**FAN CONTROL AND INTEGRATED  
ECONOMIZER TITLE 24 PROPOSAL  
CARRIER COMMENTS**

10-30-2011

Carrier Corporation

Figure 2 – AC Unit Control – M5 AC-2.2C

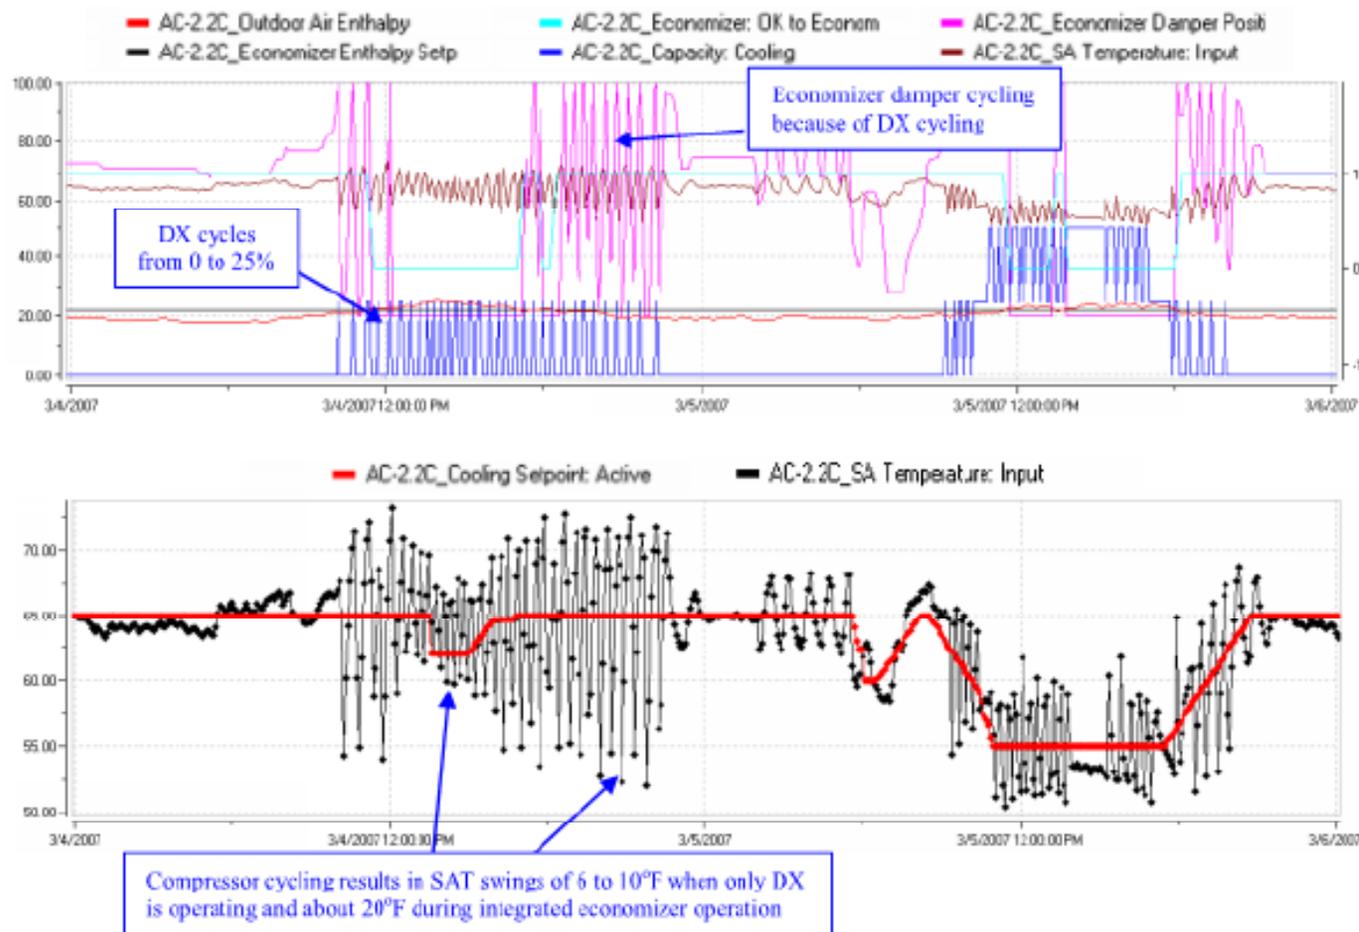
This is a referenced justification temperature trace from a VAV units that had a minimum capacity step of 25% where the dampers and compressor were fighting each other

This is a VAV units that already has 4 stages of capacity and just dropping the capacity control to 20% from 25% will not solve the problem. It require controls changes

# Typical 5 Ton Single Stage Rooftop

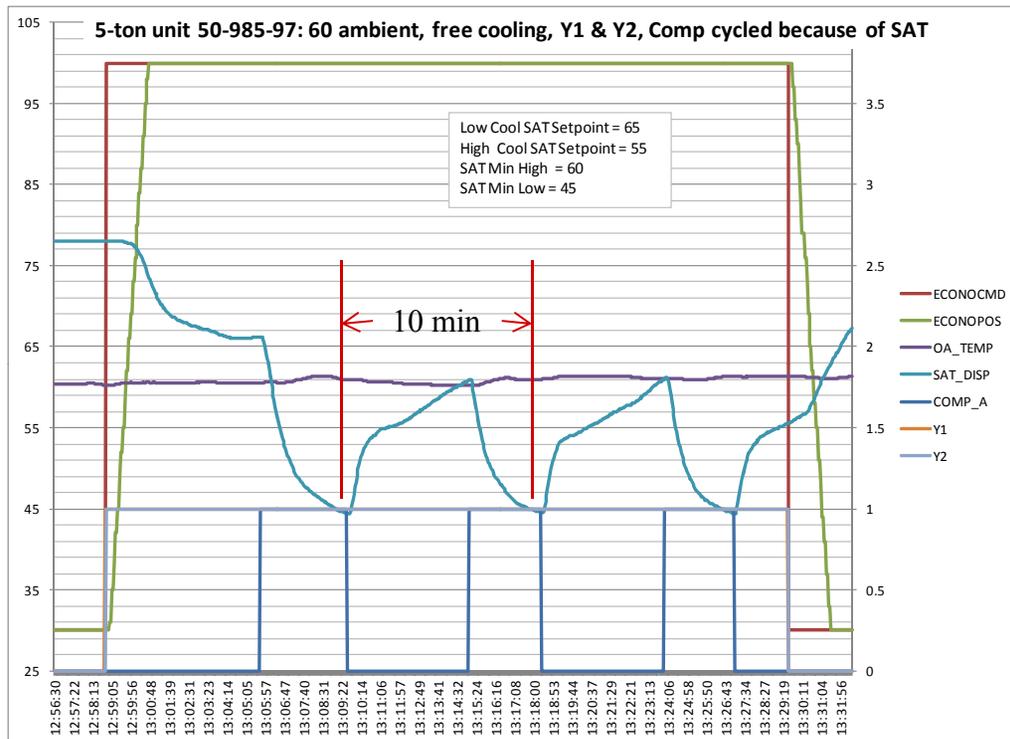
This is a trace from an actual Carrier 5 ton unit with a single compressor where the dampers are locked open and the compressor cycles on and off at duty cycle of around 10 minutes. There is degradation in performance due to the lower suctions and cycling but this was reflected in the original ASHRAE 90.1 economizer analysis and is significantly less than the assume used for the Title 24 and ASHRAE justification which assume a 25% loss in all economizer operation

Addition of two stages of capacity will further improve this and many of the units already have two mechanical stages

This the worst case with a single compressor but it shows with proper controls that the full benefit of the economizer is obtained

# Integrated Economizer Example

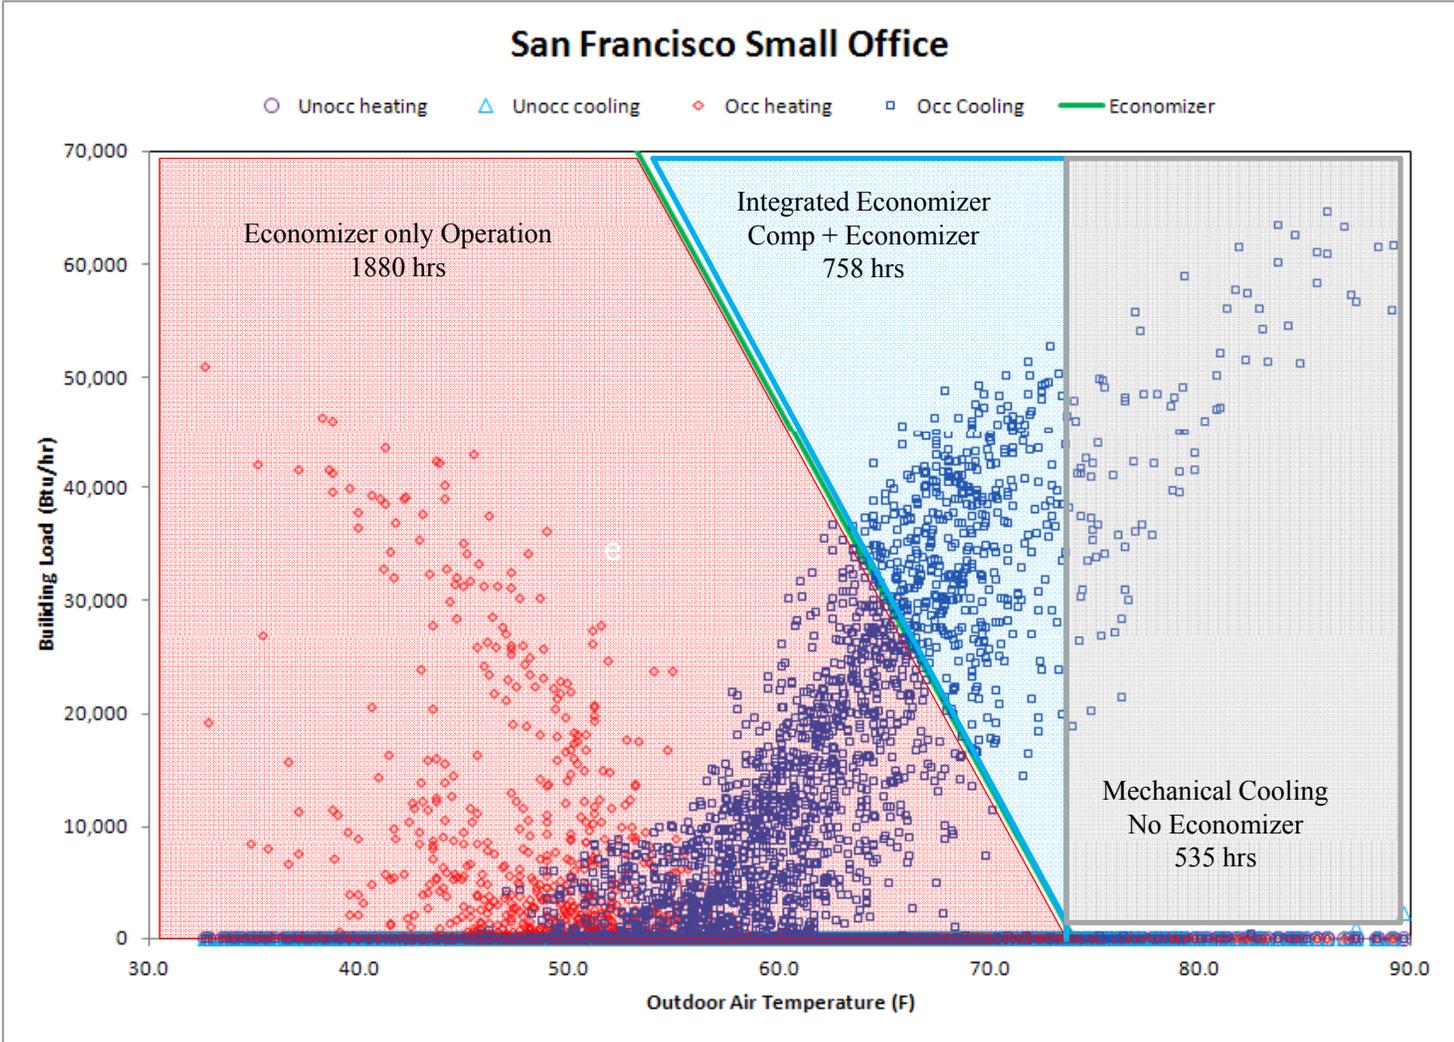
The following shows the building load profile for the 5,400 ft<sup>2</sup> office building in San Francisco which is a high economizer use climate zone. Highlighted are the operating hours where economizer only can satisfy the load, economizer plus compressors are used (integration) and compressor only are used (mechanical cooling).

- In the prior building load plot this results in only taking credit for 1978 hrs of economizer and essential giving no energy savings at all to integrated operation and actual de-rates some of the economizer only operation.

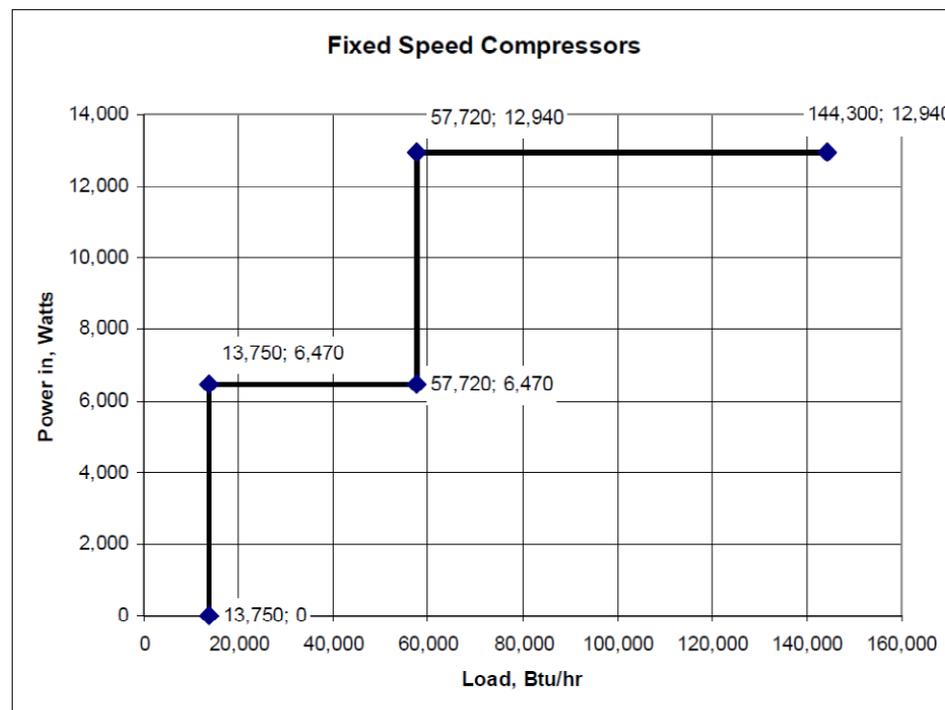
- In one of the referenced papers a plot was shown that indicated variable speed compressors are significantly better at reduced load. **This curve is totally wrong.**

This curve is saying that at part loads the compressor power is constant which is wrong. A single compressor will cycle and the power will be the integrated sum of the on-off power plus a degradation factor for startup

The degradation coefficients are well defined and are test derived for residential systems. There is a conservative default that can be used and is defined in AHRI 210/240 and AHRI 340/360 and is used in SEER and IEER ratings.

# Real Compressor Efficiency Curve

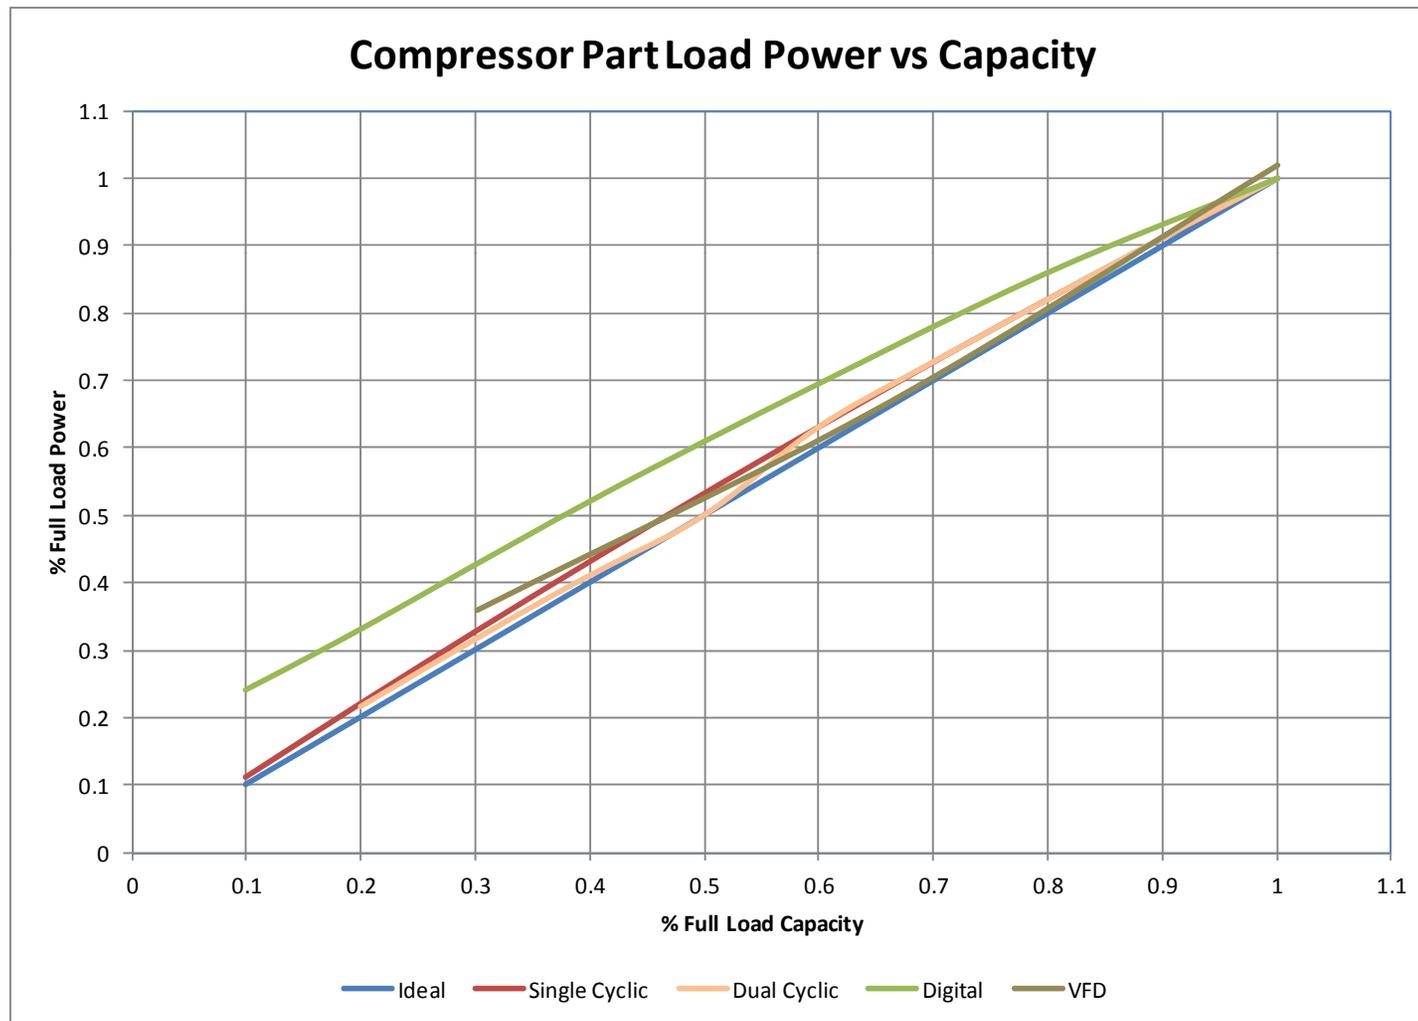
This is a correct plot of the % full load compressor power vs the full load % capacity at a constant saturated suction and saturated discharge

# Alternate Compressor Plot

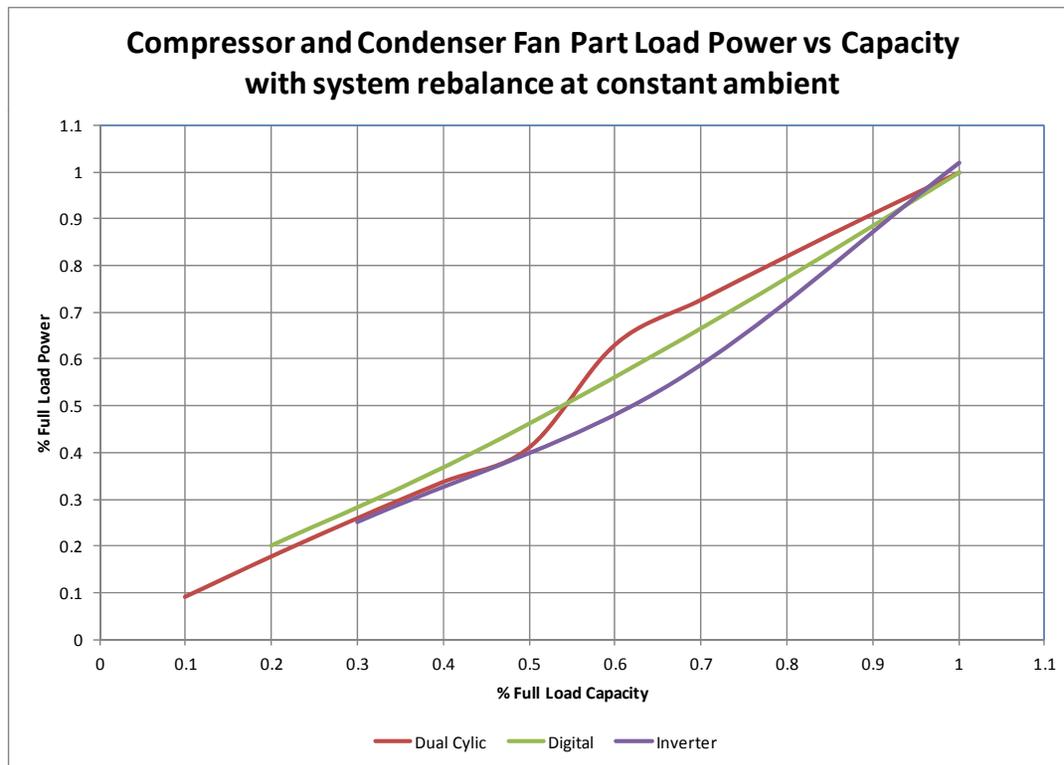
- The prior plot is misleading as it is only a compressor plot and does not factor in the rebalance of the heat exchangers as they unload in a real system.
- I created a plot of various compressor options to show what a real system impact would be.
- This is a plot of compressor and condenser fan power at a fixed ambient and return air condition

The huge performance improvement is not there and dual compressors on a single circuit perform better than a digital and close to that of a full variable speed with much lower complexity

This is actual confirmed in that most who use the digital have to limit the capacity unloading to get a good SEER

Also note that the variable speed can only get done to 30% and the requirements is 20% which is more like 15% displacement which would require dual compressors.

Costs provide to Title 24 analysis were based on single compressor digital

Figure 5. Combined Measures: Fan Control and Integrated Economizer – Single Zone DX:  
% design fan speed versus % design cooling load for a representative zone

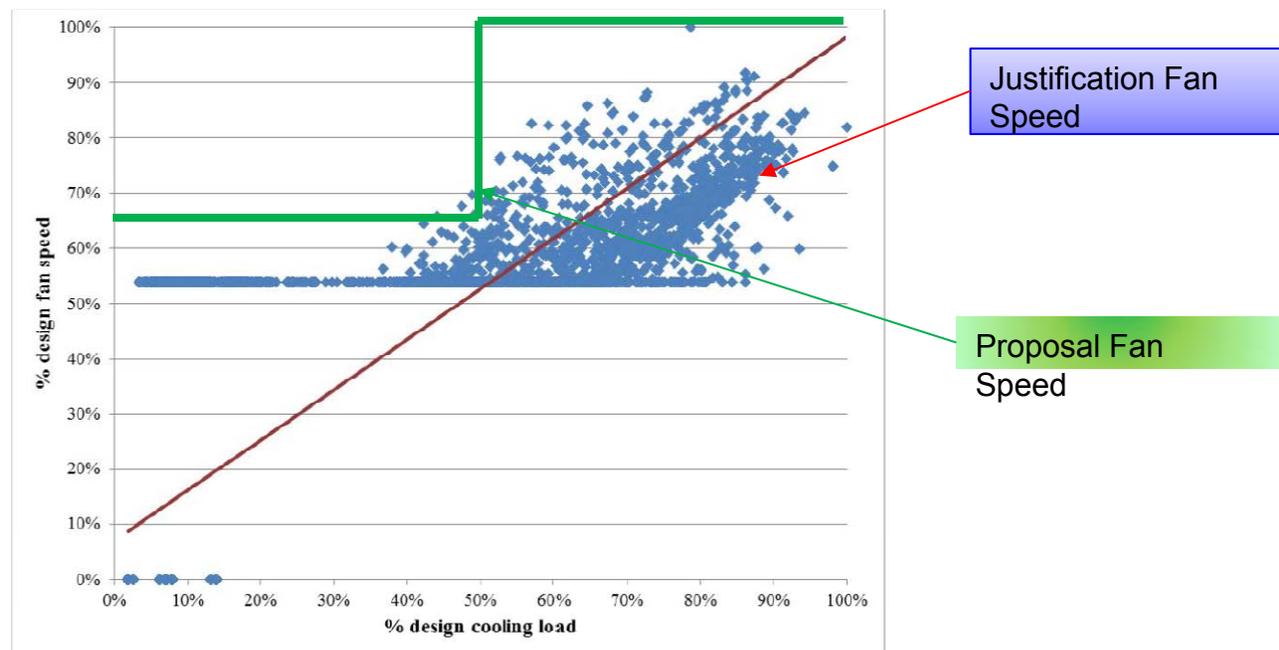
- The proposal requires for DX products a fan speed of 66% below a load of 50%
- For ASHRAE 901. The justification document assumed Variable speed fans starting at 100% load down to a speed of 50% at 50% load
- This would indicate the savings might be overstated, but the proposal also assumed very high fan and motor efficiencies and reduced the savings. In our analysis we actual found the savings are greater
